ACP-2021-006 - ENABLING BVLOS UAS OPERATIONS FROM KEEVIL AIRFIELD

STAGE 2 DESIGN OPTIONS FEEDBACK V2

Option 3 – Danger Area

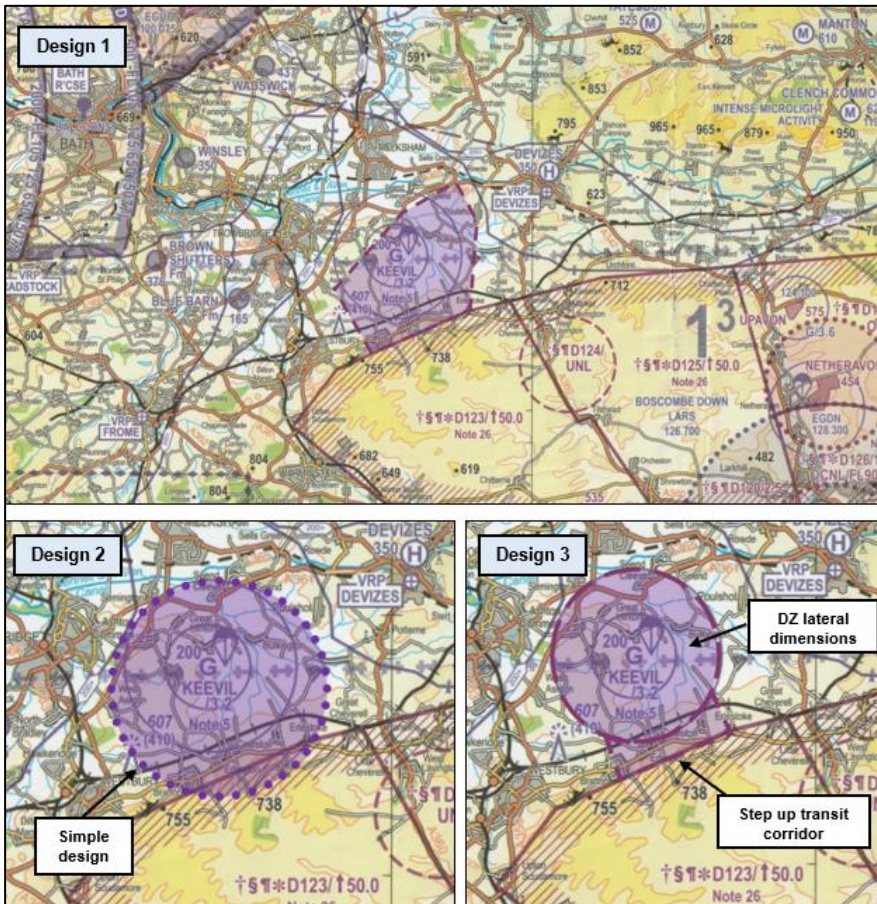
Lt █	RNAS Yeovilton			DP - A DP - B DP - C DP - D DP - E DP - F	Option 3 - Danger Area			
Mr █	None			DP - A DP - B DP - C DP - D DP - E DP - F	Option 3 - Danger Area		By selecting Option 3 and Design 3 this does concentrate activity from Keevil to SPTA over a few villages and other houses out with villages, so careful consideration must be made in relation to the amount of time the drone is active over that area, preferably only active to gain access to SPTA.	The Sponsor agrees that different shapes and sizes of the Design Options will result in changes to the level that some Design Principles can be met. More specifically, DP-F (Minimise the impact of operating noise to local residents) will be better met with a larger and higher airspace Design Option, but that it will then consequently negatively impact on other Design Principles. The Sponsor thanks the Stakeholder for their feedback and will specifically address this matter during the Stage 3 consultation process.
